TECHNICAL SERVICE BULLETIN

Transmission Not In Park Message When Driving Below 10kmph

26-2159

This bulletin supersedes 25-2160. Reason for update: Add/Remove/Update Symptoms/Summary/DTCs, Add/Remove/Update Vehicle Qualifiers/Models, Add/Remove/Update Vehicle Model Years, Add/Remove/Update Production Dates, Add/Remove/Update Parts/Part List, Revised Service Procedure (TSB/GSB) / Text (SSM)

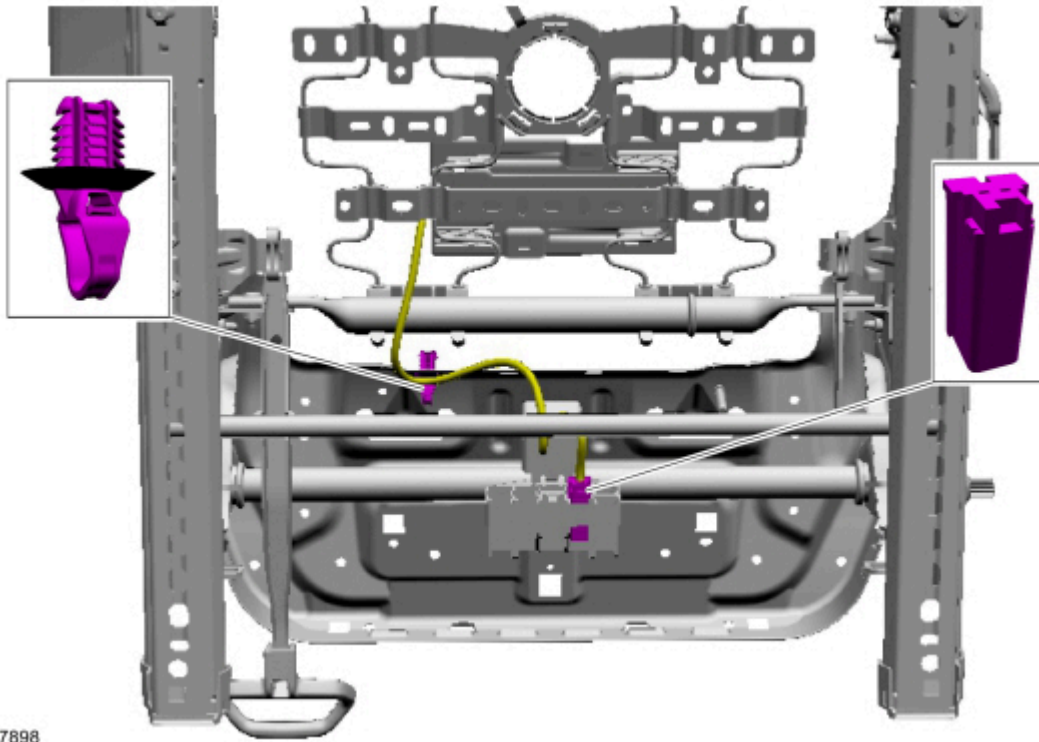
1. Install a new seat occupant sensor **and** front seat cushion foam (see Parts Required). For additional information, refer to 2024 Transit Custom / Tourneo Custom Workshop Manual Section 501-10A.
 - Make sure that the edge clip is located at the indicated position. If required, move the edge clip away from the seat occupant sensor channel in the foam (approximately 40-50 mm).

E467191

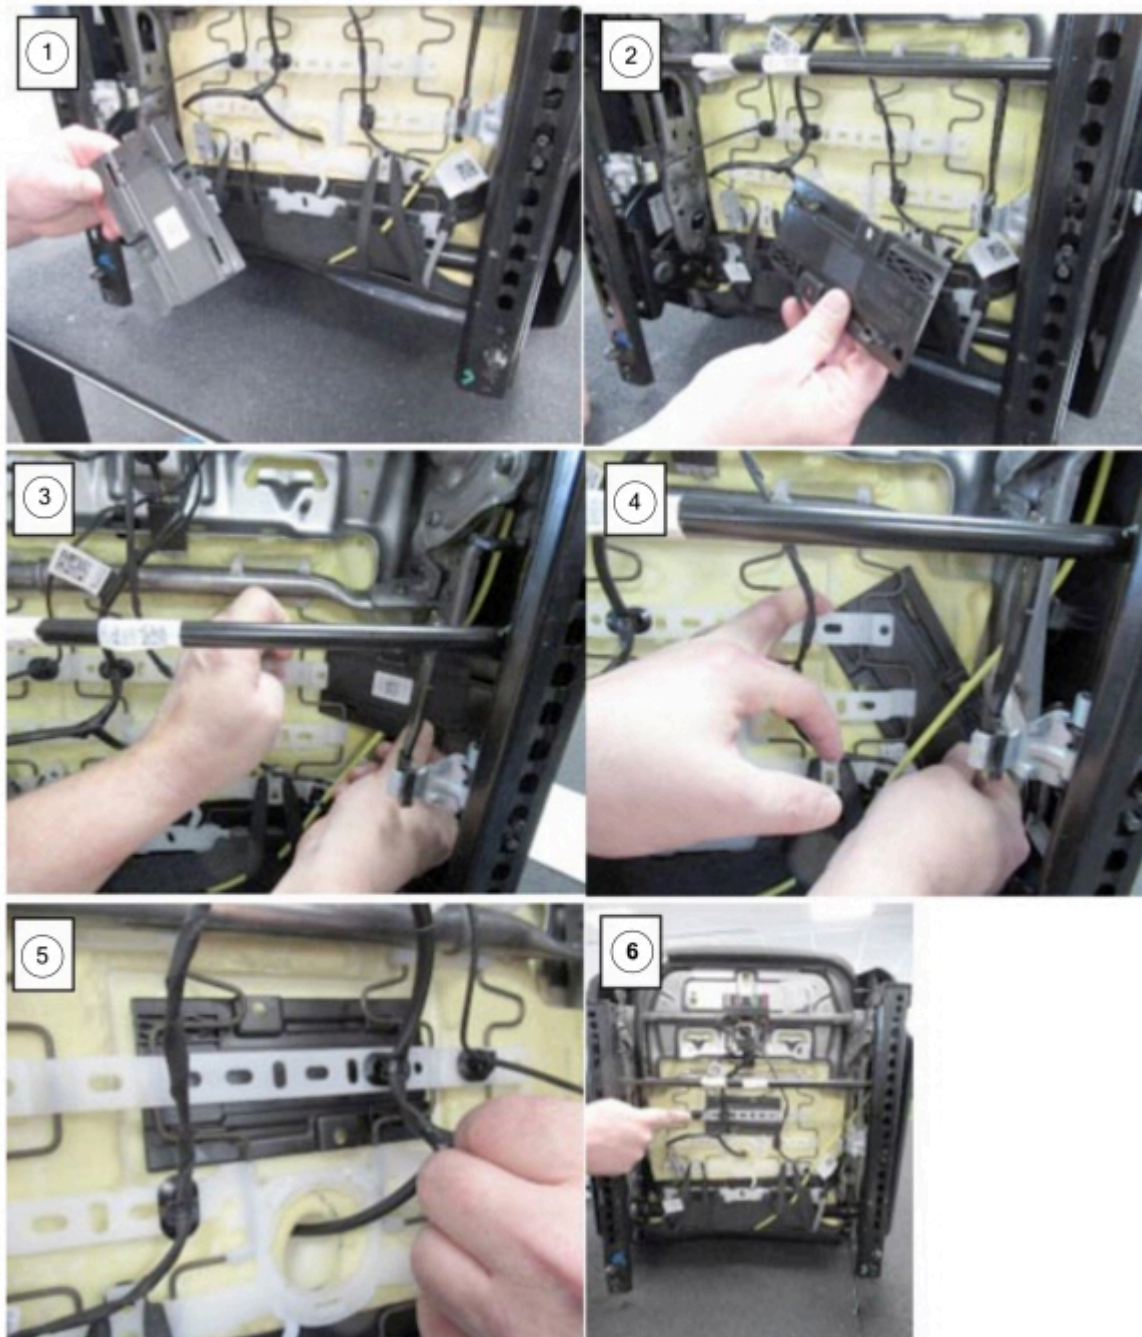
By installing the plastic bracket (see Parts Required), which increases the stiffness of the suspension mat, consequently increase of the sensitivity. The bracket can simply be slid from below under the suspension mat.
